FINAL ORDER

Special Standards Request Form

(2) Start Card Number(s)(for work to be done): 208145 original well log MARI2042

- (7) Diagram showing the pertinent features of the proposed well design and construction:
(attach additional pages if needed)

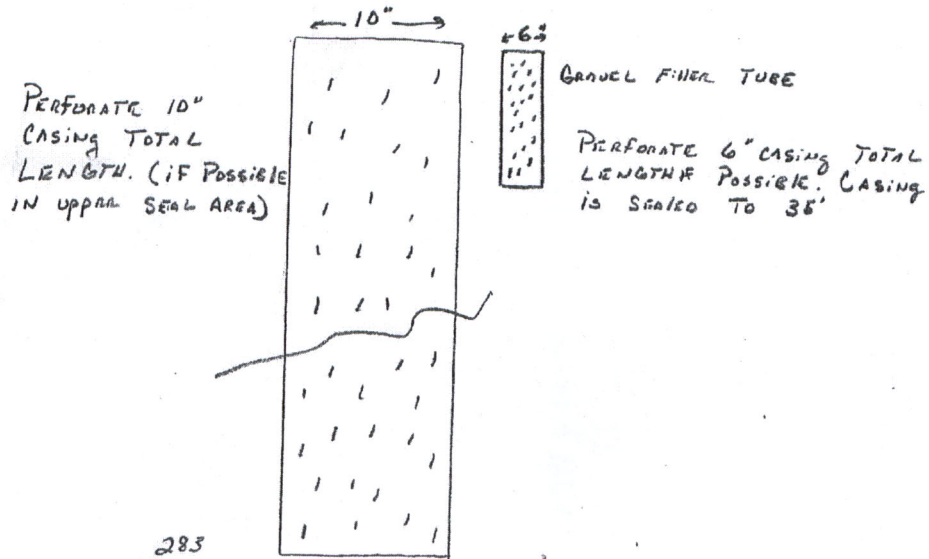
(5) The unusual site conditions which necessitate this request: This is a gravel pack

well that has pumped lots of fine shallow sand over the years.

We recently had a drill rig working on this well and a sink hole appeared under the rig. The ground is to unstable to

(6) The proposed construction methods that the bonded well constructor believes will be jack up adequate for this well: (attach additional pages if needed) _____ out casing.

Perforate the 10" casing from top to bottom. Seal with cement grout under pressure to force grout out through the gravel pack. Clean out gravel inside of 6" gravel filler tube/casing
Perforate 6" gravel filler pipe and seal with cement grout.

The Special Standards Request Form you submitted for owner: Woodburn Nursery & Azaleas Incorporated, Start Card number 208145, is hereby approved for the following: You may abandon this gravel packed well and fill tube in-place with cement grout as described on your Special Standards Request Form. Your Special Standards Request Form is enclosed. All other standards must be adhered to.
